Service Bulletin

Release of NX 2.0.8900 / 3.0.8900, XRDI 16, ASC 2.0 and CDI 3.3 with system version 5.1

Title:	DX-D 100 - Service Bulletin No. 61 - Release of NX x.0.8900_XRDI 16_ASC 2.0_CDI 3.3 with version 5.1
Livelink ID:	47812640
Version#:	14
Version Date:	2015-01-22 09:47 AM CET
Status:	Approved on 2015-01-27 11:06 AM CET
Owner:	Michael Roeser (exfrm)
Created By:	Michael Roeser (exfrm)
Created Date:	2014-11-26 10:31 AM CET
PDF Creation Date:	2015-01-27 11:07 AM CET

Figure 1

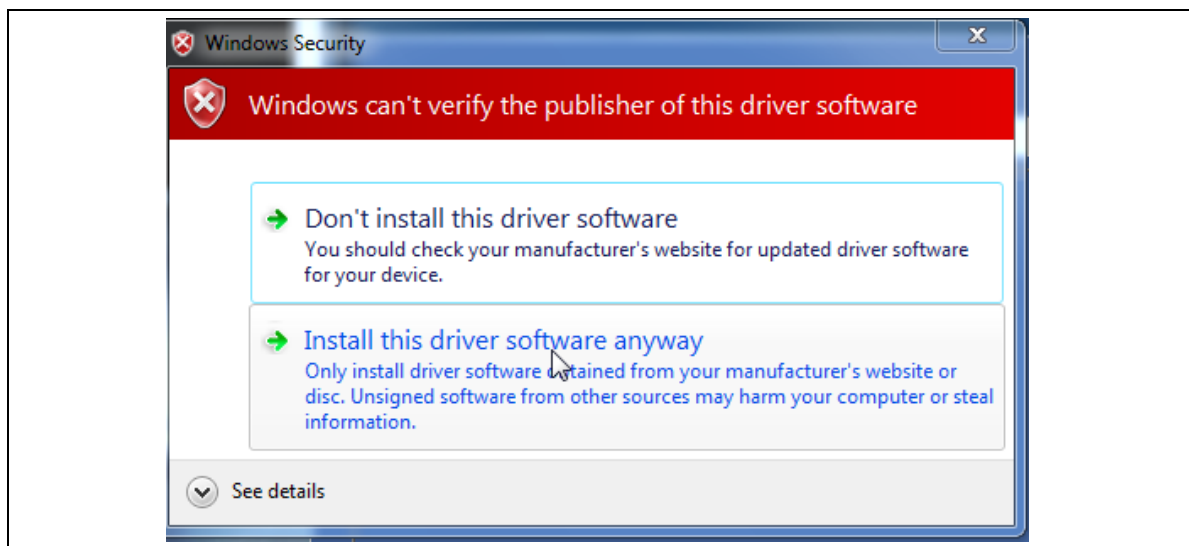
Note that the following error may occur during installation!

Symptom During installation, Windows security triggers a pop-up message

Cause

Solution Workaround solution: Select “Install this driver software anyway”.
